Dual Generator Specifications and Requirements

BULLETIN

This bulletin outlines changes to the Facilities: Power and Grounding Standard with regard to the use and deployment of a dual generator solution in all Comcast facilities.

Figure 2-6: Minimum distances in space-constrained environments

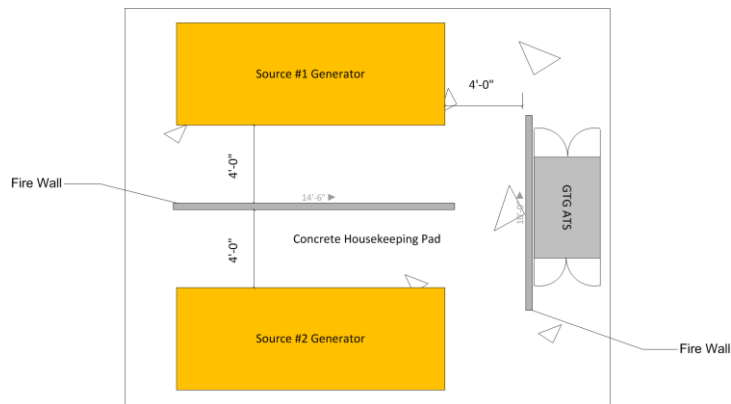
2.5.6 Exception: When adequate space is limited, the distance between any of the components above may be reduced to a minimum of code and manufacturer required working clearance (generally 3'-4') when a proper fire wall is constructed along the entire length and height of the component.

2.5.7 Fire wall shall be engineered and constructed to provide appropriate support of the fire wall and to be compliant with local code requirements
